Access Compliance Report

Public Rights-of-Way

(Island Curb Cuts)

Intersection ID: 21746	Main Street: INTERNATIONAL_DR	Cross Street: PROVIDENCE_RD	Location: NE
ADA ID: 294F7F8B1AAF	Curb Cut Type: MedianRefuge2	Initial Pass/Fail: Fail	Overall Compliance: No
Codes/Mitigation Info/Possible Solution		Field Measurements/Component Compliance	
Severity Score: 12.5

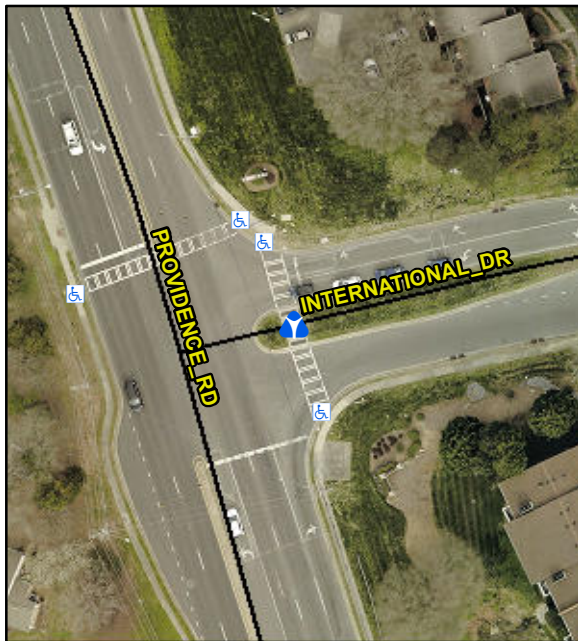
Compliance	Description	Data	Compliance	Description	Data
Yes	Refuge 1 Length (In)	111.5	N/A	Gutter 1 Ponding?	N/A
Yes	Refuge 1 Width (In)	99.0	N/A	Gutter 1 Lip Ht (In)	N/A
Yes	Refuge 1 Slope (%)	1.0	N/A	Gutter 1 Slope (%)	N/A
No	Refuge 1 X Slope (%)	9.3	N/A	Gutter 1 X Slope (%)	N/A
N/A	Painted X Walk1?	Yes	N/A	DWS 1 Provided?	N/A
N/A	X Walk 1 Direction	To NW	N/A	DWS 1 Contrast?	N/A
N/A	X Walk 1 Width (In)	107.0	N/A	DWS 1 Length (In)	N/A
N/A	Road 1 Slope (%)	6.5	N/A	DWS 1 Full Width?	N/A
N/A	Road 1 X Slope (%)	5.9	N/A	DWS 1 Offset (In)	N/A
Yes	Refuge 2 Length (In)	111.5	N/A	Gutter 2 Ponding?	N/A
Yes	Refuge 2 Width (In)	99.0	N/A	Gutter 2 Lip Ht (In)	N/A
Yes	Refuge 2 Slope (%)	1.4	N/A	Gutter 2 Slope (%)	N/A
No	Refuge 2 X Slope (%)	7.0	N/A	Gutter 2 X Slope (%)	N/A
N/A	Painted X Walk2?	Yes	N/A	DWS 2 Provided?	N/A
N/A	X Walk 2 Direction	To SE	N/A	DWS 2 Contrast?	N/A
N/A	X Walk 2 Width (In)	107.0	N/A	DWS 2 Length (In)	N/A

Remove & Replace Entire Refuge.
